YEAR 3 MONITORING REPORT

ROSES CREEK STREAM MITIGATION SITE

Burke County, North Carolina
NC DMS Project # 96309

RE: NCDEQ – Division of Mitigation Services
Roses Creek MY 3 Monitoring Report
DMS Project Number: 96309
Response to DMS Review Comments on Draft Year 3 Monitoring Report for Roses Creek

Figure 6.1 – 6.3 Tributary Water Level Gauge Meter Data

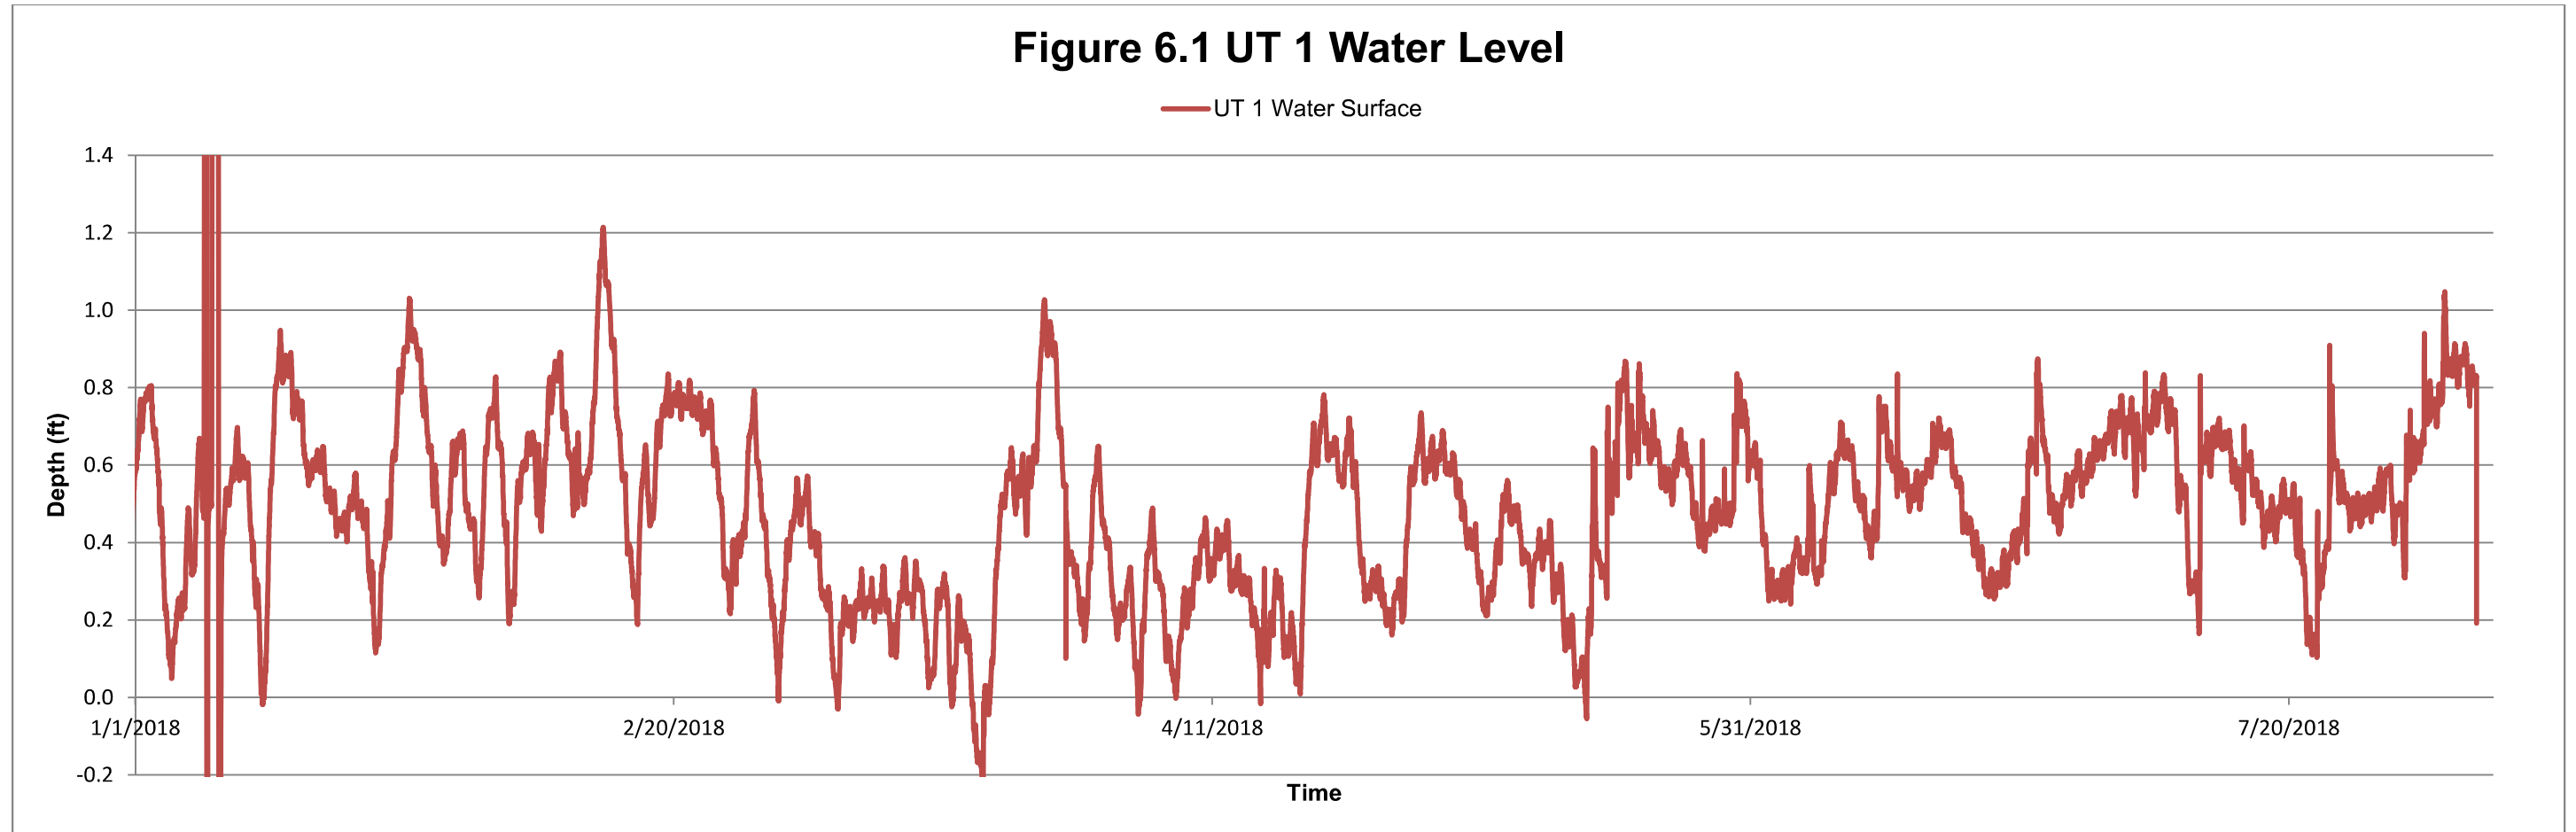
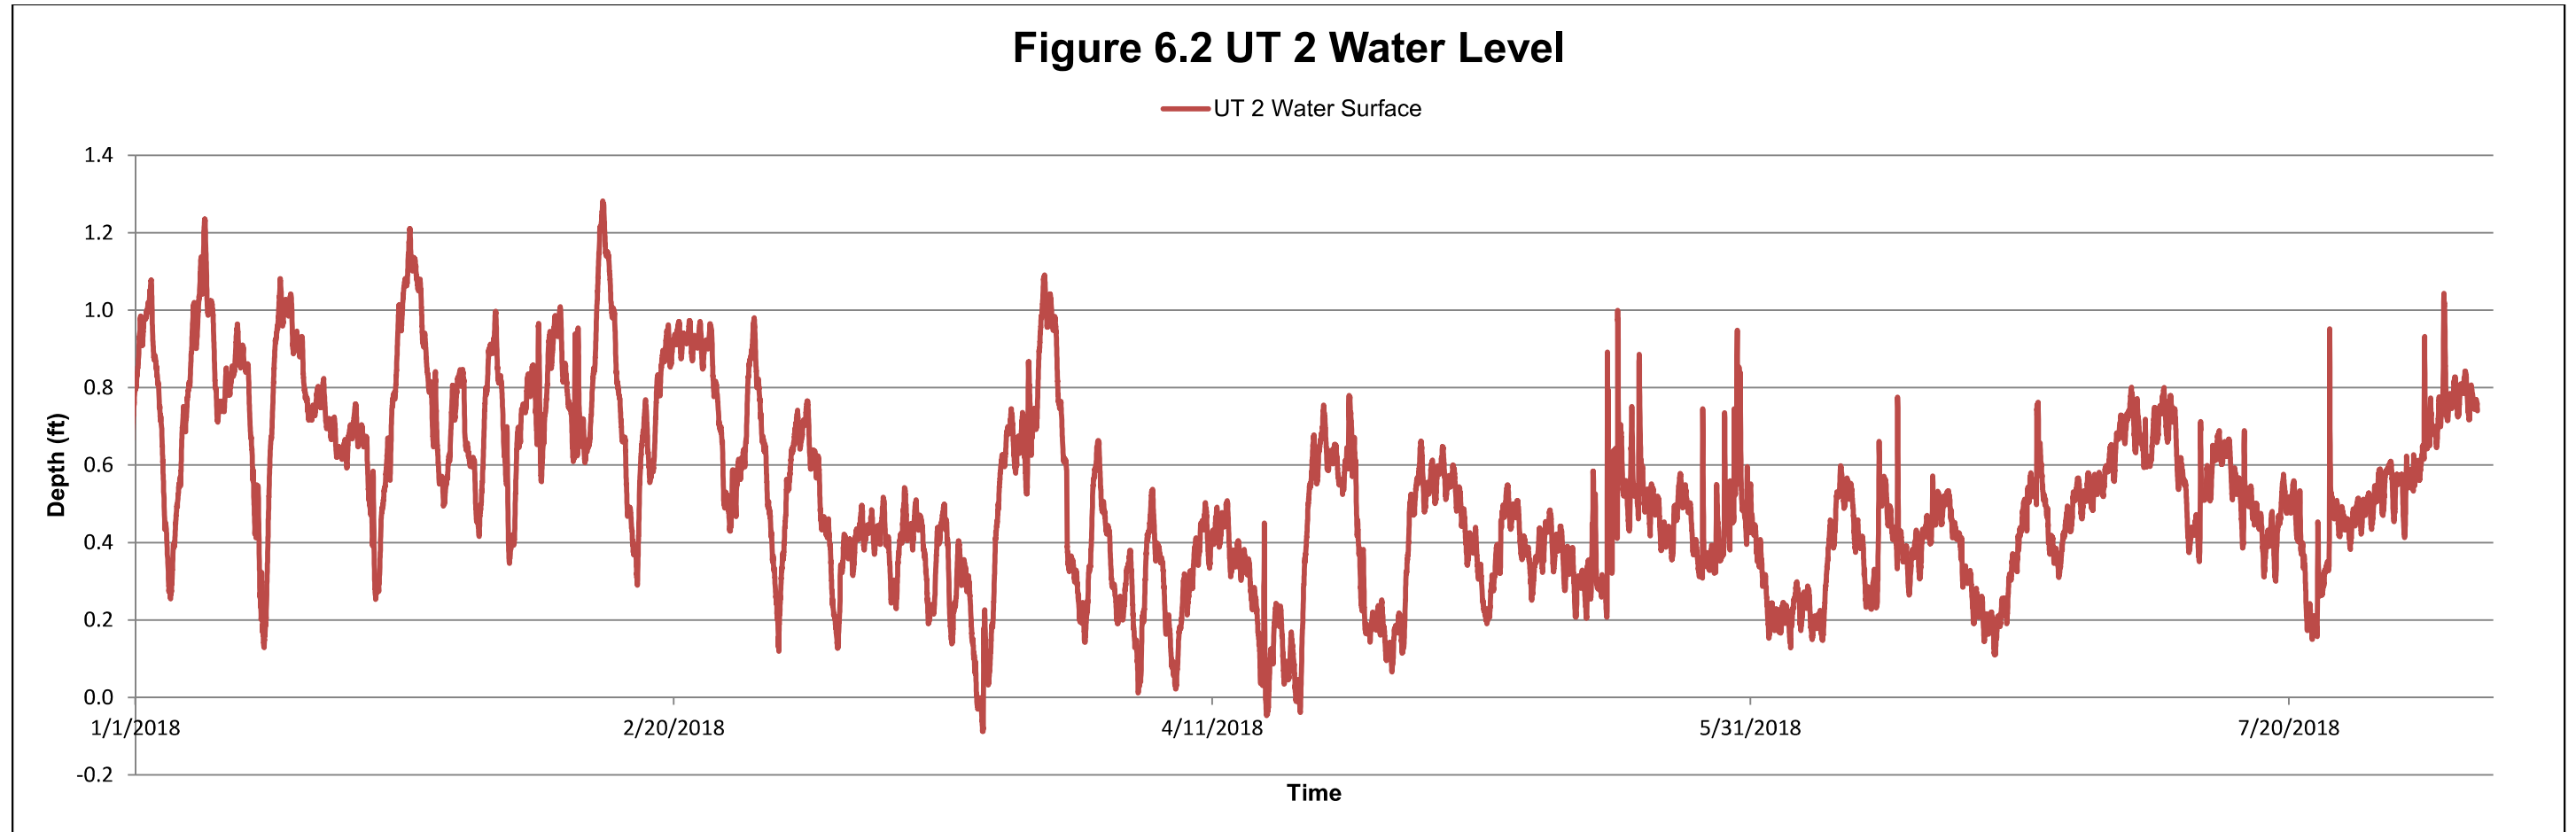
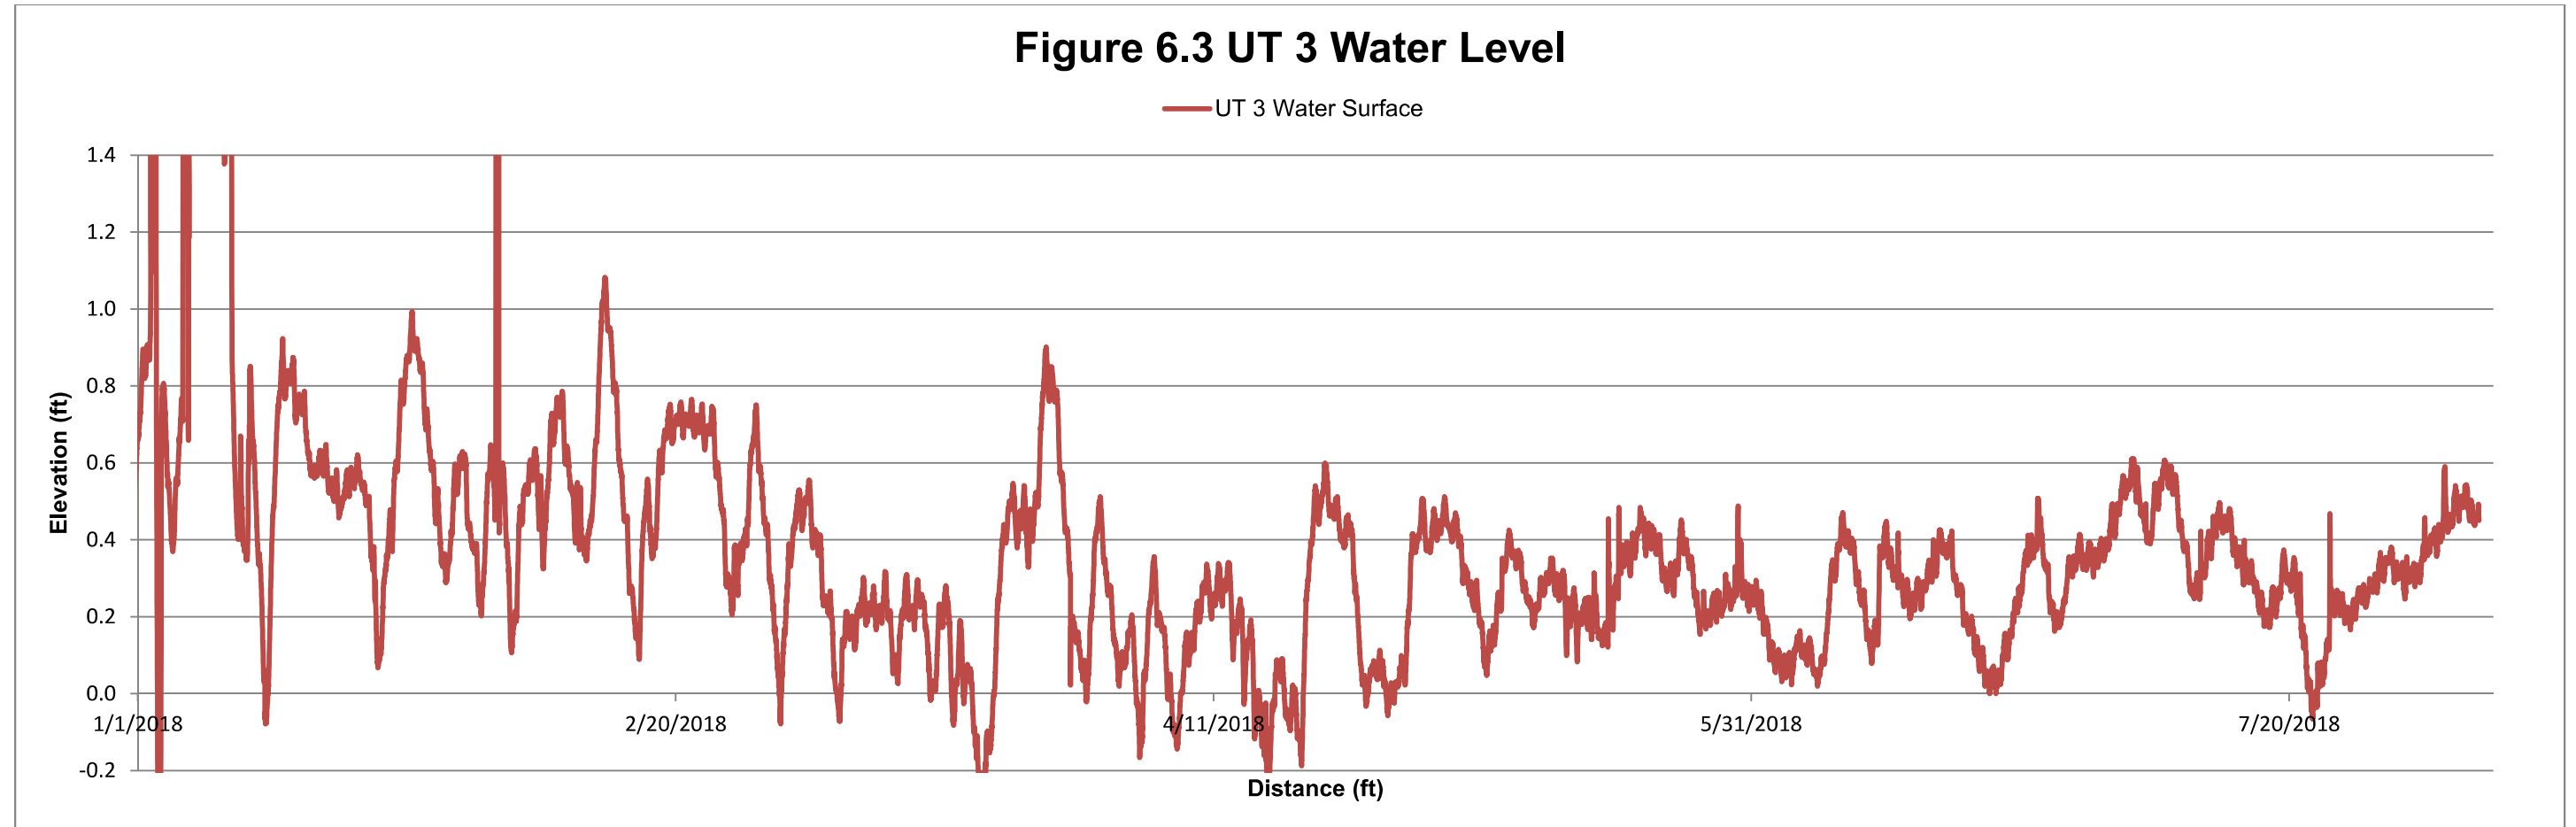
6. Surface Water Level Meter Data – The water level graphs are hard to follow and should only present the current monitoring year time frame for clarity; the sensor level should be shown; rain data should be shown concurrently if possible; following is a good example.

Response: The water level meter graphs have been edited to show the current monitoring year only.

Figure 7. Roses Creek Adaptive Management Map- MY3

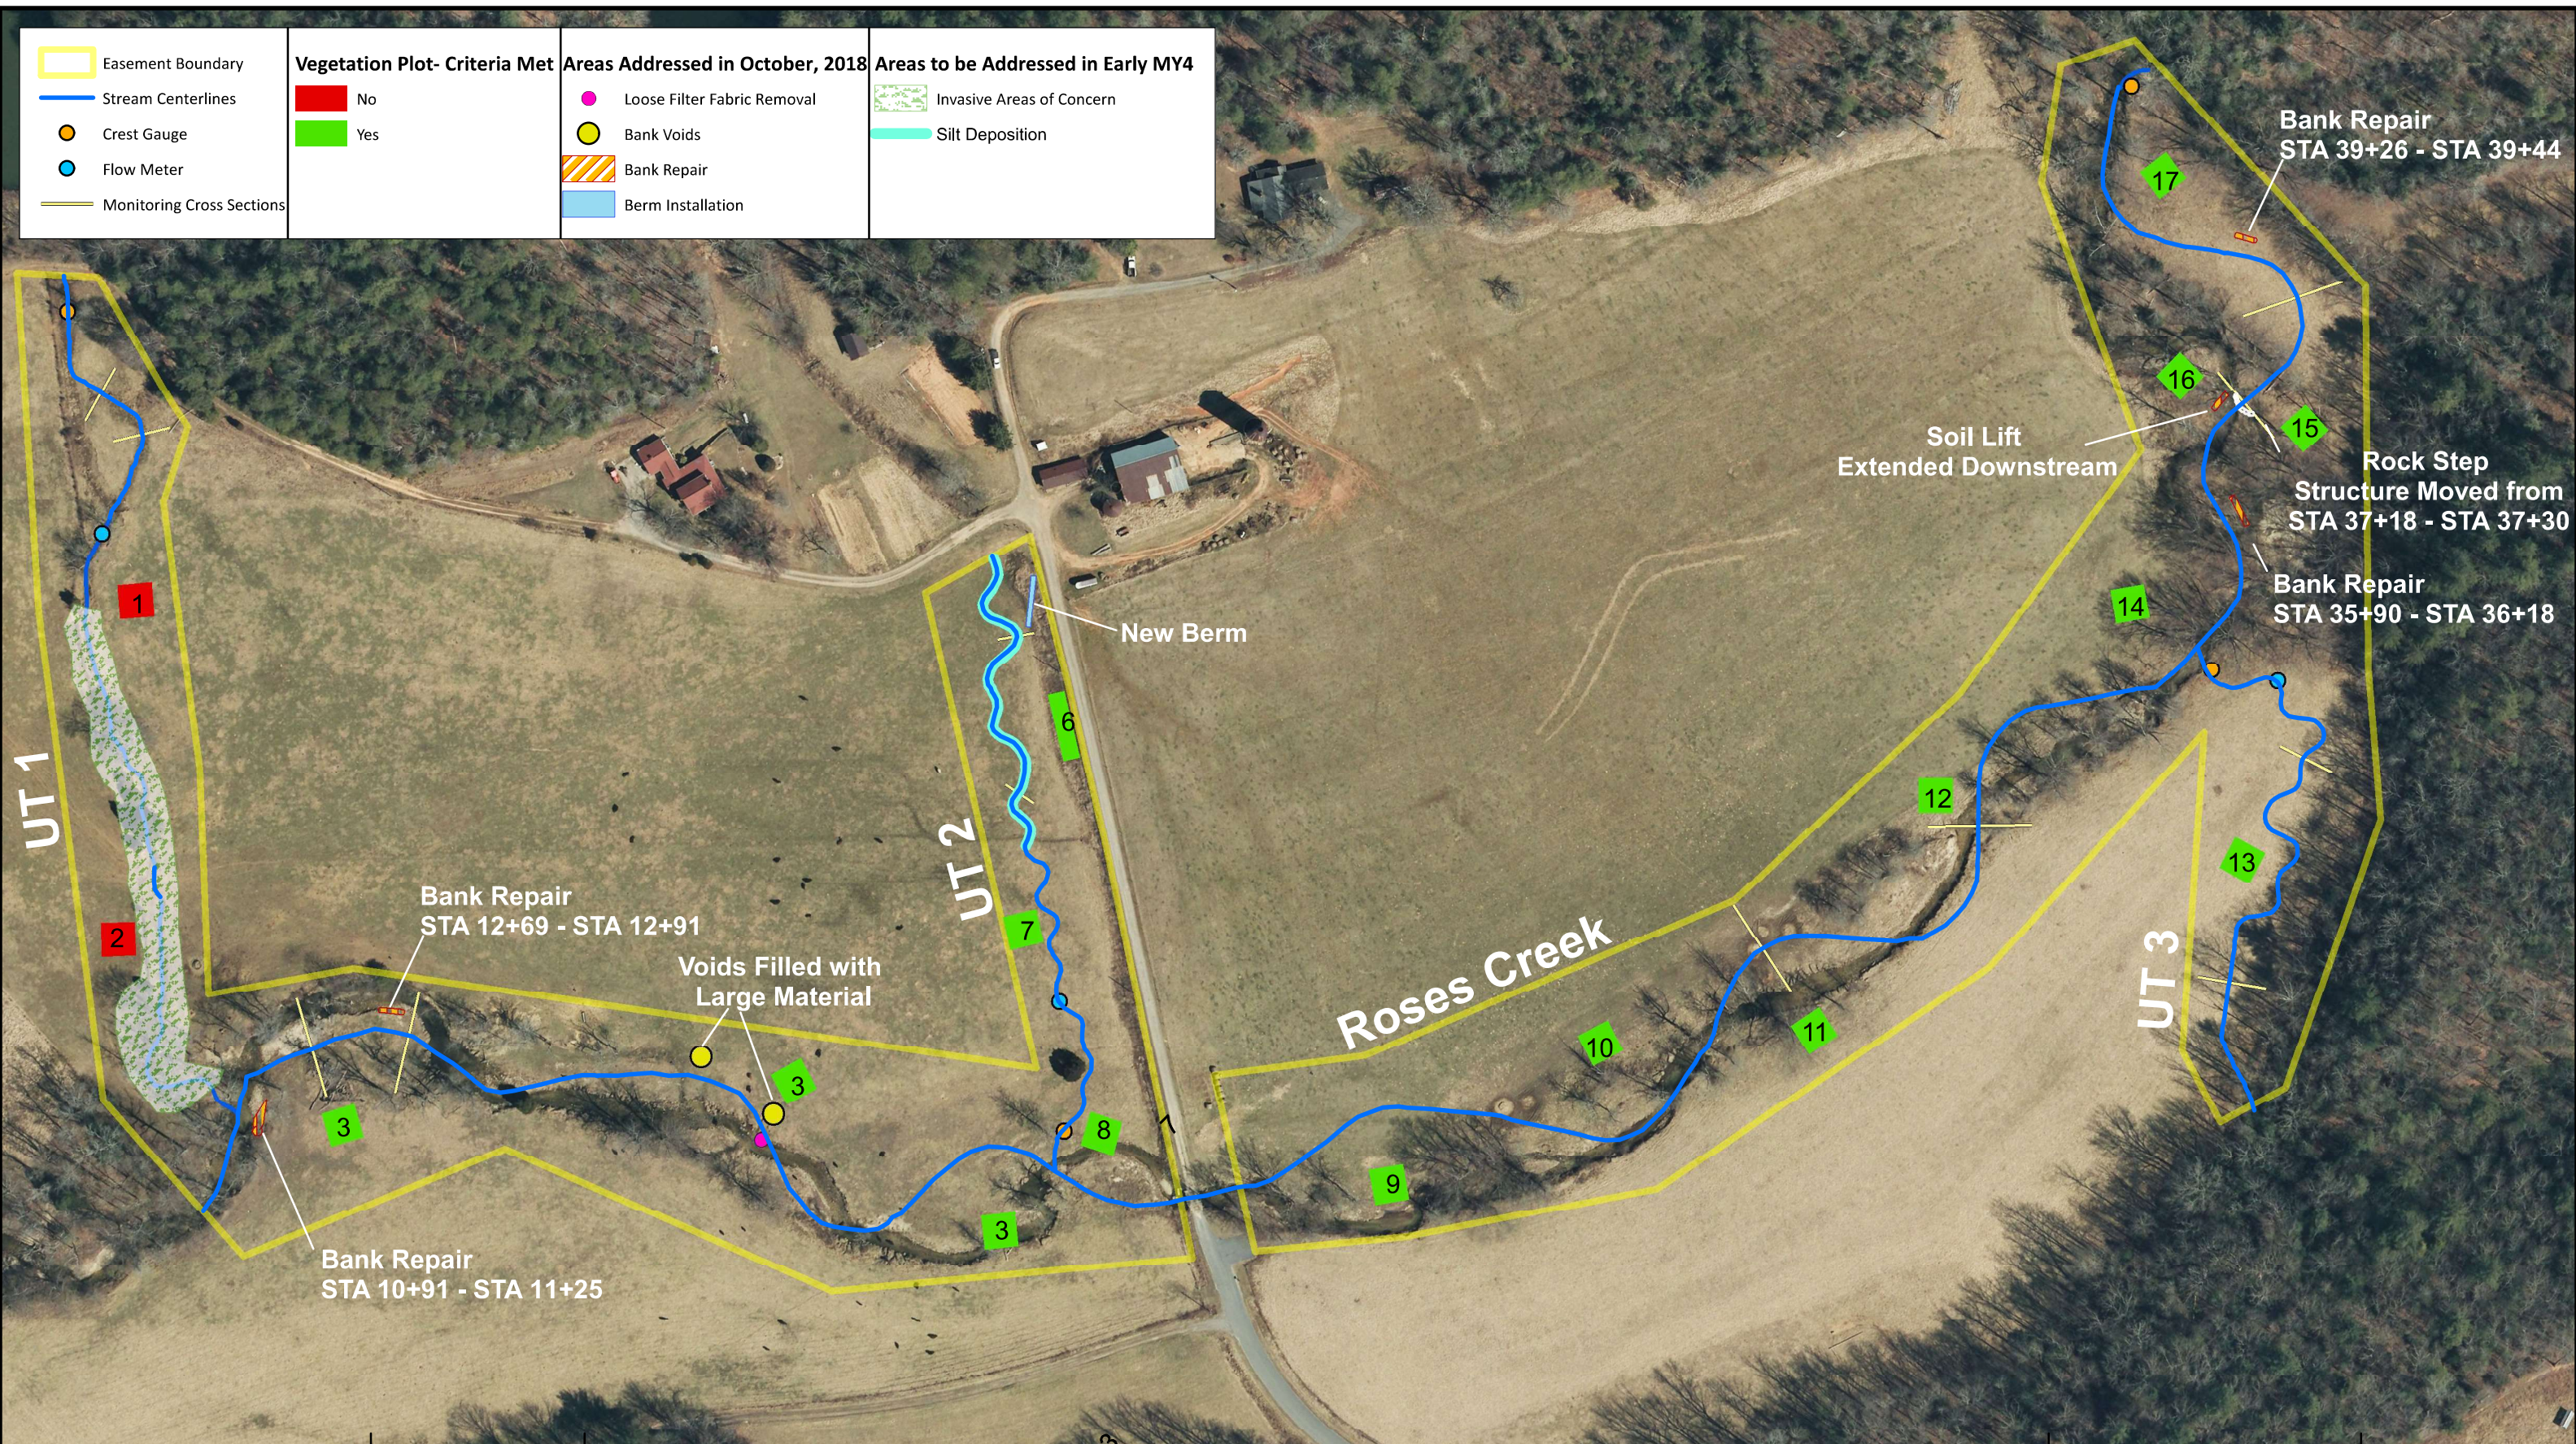
4. HDR have done a nice job and been proactive about stream repairs (and planting); the repairs looked generally good following Hurricane Florence; recommend that the 2018 repair areas be shown on a separate Adaptive Management map, similar to the map you developed for the supplemental planting in 2017, showing clearly what was done and where.

Response: The CCPV has been updated to show areas that are currently of concern. Many of the areas shown in 2017 were addressed during the repair work in October, 2018. A separate Adaptive Management Map has been included in the report in Appendix F. This figure shows areas that were repaired during 2018 and areas to be addressed in the near future.

Response: Thank you. An Adaptive Management Map has been created and is included in Appendix F.
